**RE: Project File #: PUDSP-21-009
 Project Name: Mayberry Phase 1
 Parcel Nos.: See attached parcel list**

EXECUTIVE SUMMARY

PUD DEVELOPMENT PLAN/PRELIMINARY PLAN AMENDMENT

Figure G.1: Placetype Map

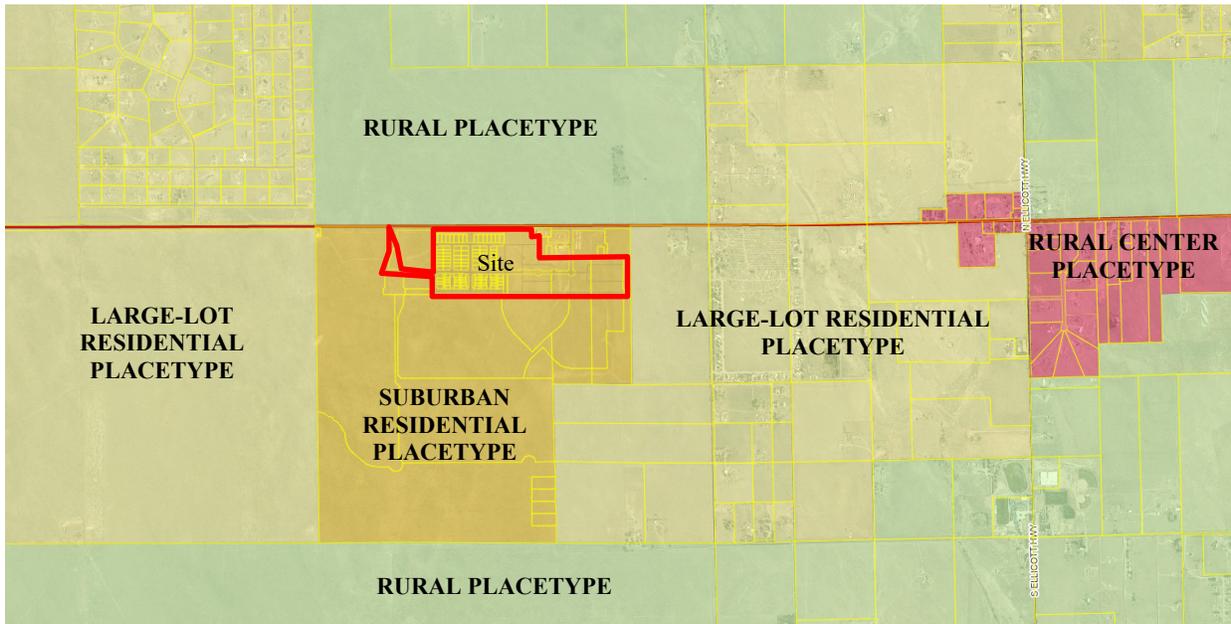
Mr. Carlson – Looking at figure G1, these are identifying what is there now correct?

#2- Urban Knuckle – SDT Length

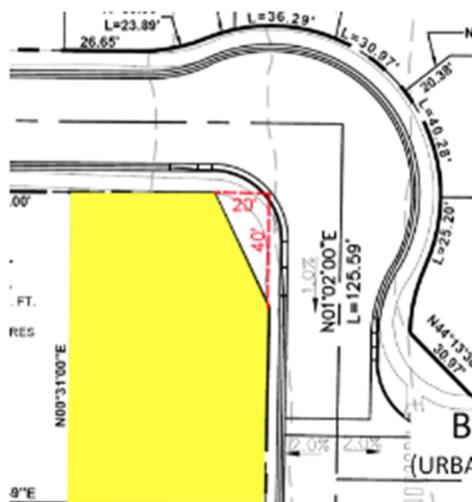
2. A PUD modification of Appendix F, detail SD_2-77 of the ECM to modify the standard sight distance triangle length at the urban local knuckle.

Detail SD_2-77 identifies a length of 40 feet for each leg of the sight distance triangle at the inside radius of the knuckle based on a 25-mph design speed. The length of each leg is proposed to be 40 feet and 20 feet, with the 20-foot leg located where the driveway access to the residential corner lot will be located.

The ECM administrator recommends approval of the requested PUD modification as the typical speed of vehicles is reduced around the curve of the knuckle to approximately 15-mph allowing for adequate sight distance. Additionally, the proposal will allow for sufficient stopping sight distance on the horizontal curve which is the intended result of the sight distance triangle legs.

Section of ECM from which Deviation Is Sought: Section F Standard Detail(SD) 2-77

Specific Criteria from which a Deviation Is Sought: The request is a modification to/deviation from Section F SD_2-77 “Urban Knuckle,” specifically the standard sight-distance triangle (SDT) length.

The proposed alternative, shown in the attached Deviation Exhibit 2 (below), would modify the length of the standard sight-distance-triangle leg from 40’ and 20’ along the street leg (extending back from the knuckle) onto which the corner lot will have driveway access. This is shown for several locations, which are shown in the attached Deviation Exhibits 1a and 1b. A copy of the ECM Urban Local Knuckle standard plan sheet (SD_2_77) is also attached for reference. The standard plan sheet shows several standard dimensions, including the inside radii and the sight-distance triangle (SDT) dimensions.

- The deviation will not adversely affect safety or operations;
The inside edge of pavement radius is 37 feet (the same as SD_2_77) and the centerline radius through this 90-degree curve/knuckle is 52 feet. Please refer to the attached Deviation Exhibit 3. Assuming a design speed of 15 mph around the curve of this knuckle, the required stopping sight distance is 80 feet. Based on Figure 2-21 in the ECM, the required "M," middle ordinate distance, centerline of inside lane to obstruction is 14.6 feet. Exhibit 3 shows the M value for the proposed sight-distance-triangle leg lengths. The measured M is 14.7. Therefore, the Stopping Sight Distance, 82 feet, on Horizontal Curve 2.3.6.C would be met.
